**ADVISORY BOARD ON
RADIATION AND WORKER HEALTH**

**SC&A CLARIFYING QUESTIONS FOR FERNALD ISSUES
MATRIX – DRAFT WORKING DOCUMENT**

February 2018

Figure 1. Chart from 2011 NIOSH Document: Issues Related to RU Dose Reconstruction Draft 01 8-5-11 (NIOSH 2011)

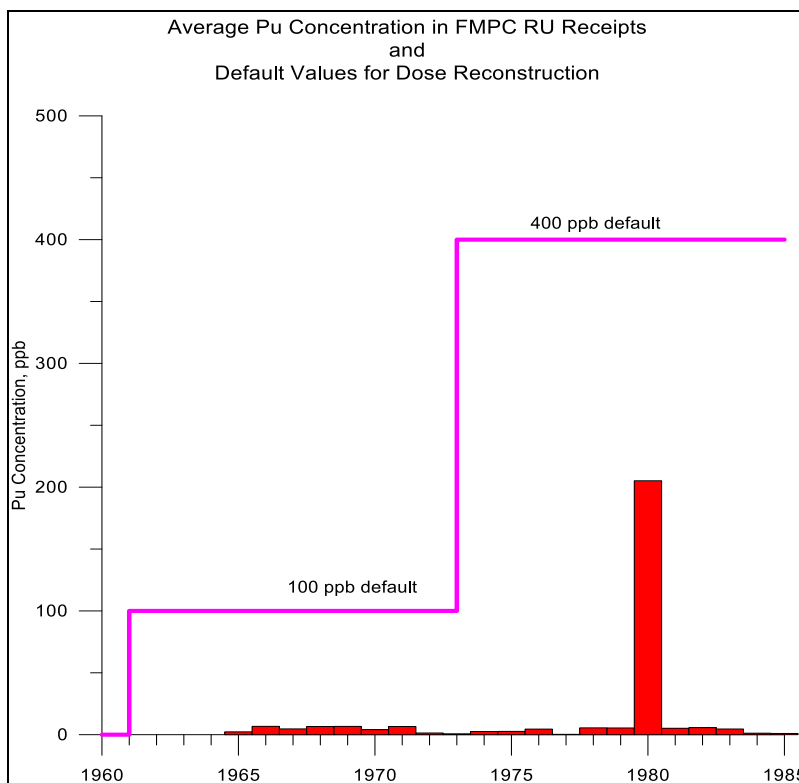
SC&A examined the original Recycled Uranium Project Report (DOE 2000) to identify which recycled uranium lots are applicable to the pre-1973 timeframe. Unfortunately, the original report does not identify a specific date with each lot sample; however, the report does indicate on page 577 that additional information on each lot sample can be provided upon request. It appears that NIOSH made such a request and received additional working documents and database files as indicated on page 3 of NIOSH 2011. In addition, NIOSH 2011 contains a chart which shows average plutonium contaminant ratios as far back as 1965 (this chart is shown as Figure 1, below).

SC&A Clarifying Question 2: How was NIOSH able to determine which lots were processed prior to 1973 as was indicated in Figure 1 (above) as well as the most recent responses contained in NIOSH 2017b?
